# SERVICE BULLETIN

**Service Bulletin No.:** DAC1-76-04 Rev 1

**Title:** Throttle Cable Firewall Feed-Thru

**Figure 1 – Angled Split Bushing Installation**

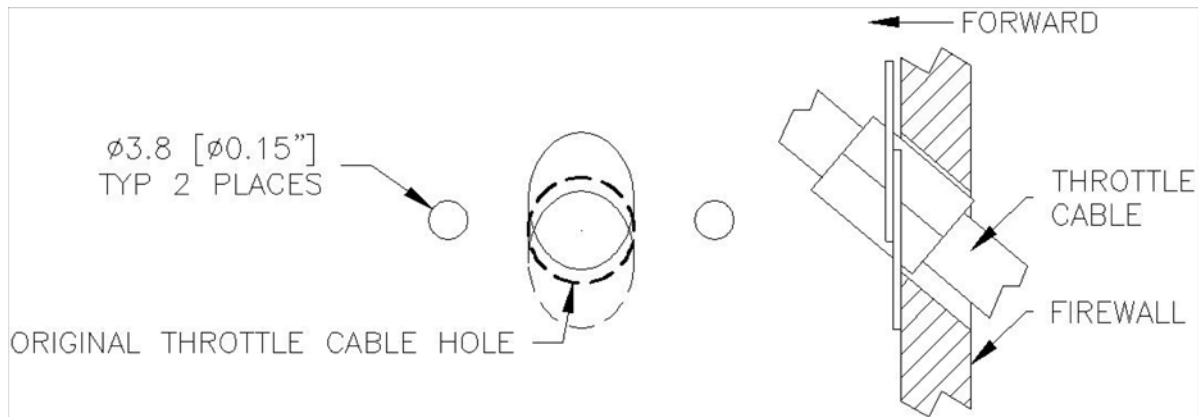
**3. General:** This service bulletin addresses the replacement of the original throttle cable firewall feed-thru with one that allows an inclined passage through the firewall to reduce the bend in the cable and consequently the possibility of the cable kinking.

Revision 1 of this Service Bulletin changes the part number for the angled split bushing at the firewall

- 10.2 Open the existing mixture cable hole at a 45 degree angle (aft and down) using a round file, so that the angled split bushing fits in the hole with the flange sitting flat on the firewall (See Figure 1). Make sure that the throttle cable is secured out of the way of the work area. Use care not to damage the surrounding firewall or equipment.

- 10.3 Locate the new holes in the firewall using the bushing and drill two holes, diameter 0.15" (3.8mm), as shown in Figure 1.
- 10.4 Put the throttle cable back through the firewall.

- 10.5 Perform Steps 5 – 8 of Section 2B, "Install the Throttle Bowden Cable," chapter 76-00 of the Maintenance Manual.
- 10.6 Install the two angled split bushing halves around the throttle cable, as shown in Figure 1, using two AN526C632R8 screws, AN960C6 washers and MS21042-06 nuts.
